Unresolved Issues for the Disposal of Remote-Handled Transuranic Waste
in the Waste Isolation Pilot Plant

Matthew K. Silva and Robert H. Neill

Environmental Evaluation Group
7007 Wyoming Boulevard NE, Suite F-2
Albuquerque, NM 87109

September 1994

Fig. 1. Estimated RH TRU inventory for emplacement in WIPP. Estimates based on U.S. DOE Integrated Data Base (U.S. DOE, 1986, 1987, 1988c, 1989, 1990d, 1991d, 1992) except where noted.

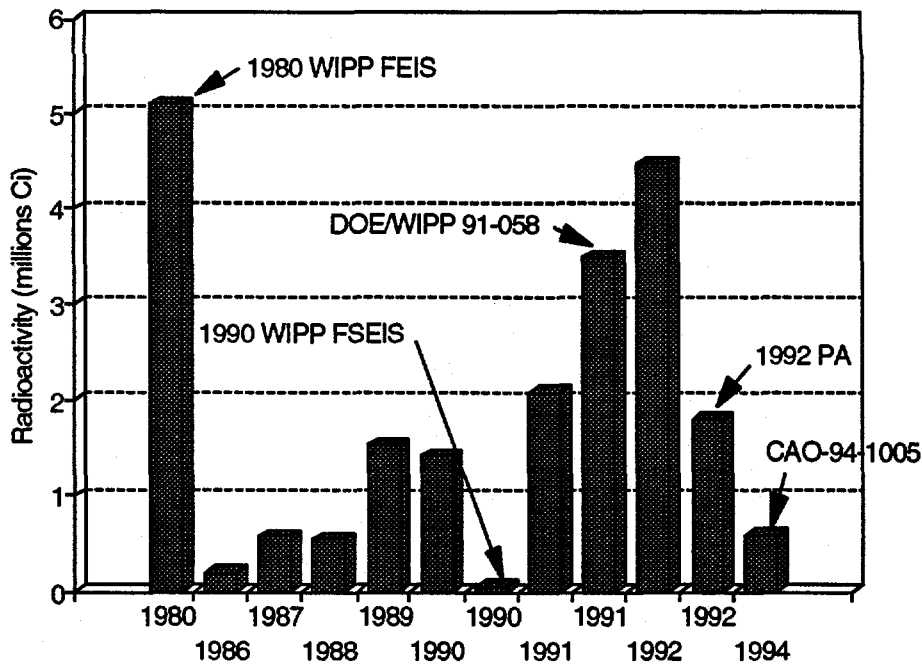
However, the RH TRU inventory has changed considerably in the last several years (Sandia, 1992, vol 3, sec. 3.4.2). Figure 1 shows the disparity in the various estimates by the DOE of the radioactivity of the RH TRU radionuclide inventory intended for emplacement in the WIPP.

The 1994 Baseline Inventory Report (U.S. DOE, 1994b) describes a proposed methodology for eliciting, from the DOE generator/storage sites, estimates of the amount of hazardous materials and the amount of radioactivity in CH TRU waste and RH TRU waste retrievably stored at each site. It appears the baseline inventory will rely, in part, on process knowledge. Process knowledge requires an evaluation of existing records on the production history of the waste. However, as observed by previous studies at generator/storage sites, records on RH TRU waste are scarce, even more scarce than records on CH-TRU waste (Jensen and Wilkinson, 1983 p. 91) and actual data on stored RH TRU waste are minimal (Stewart et al., 1989, p. 5).
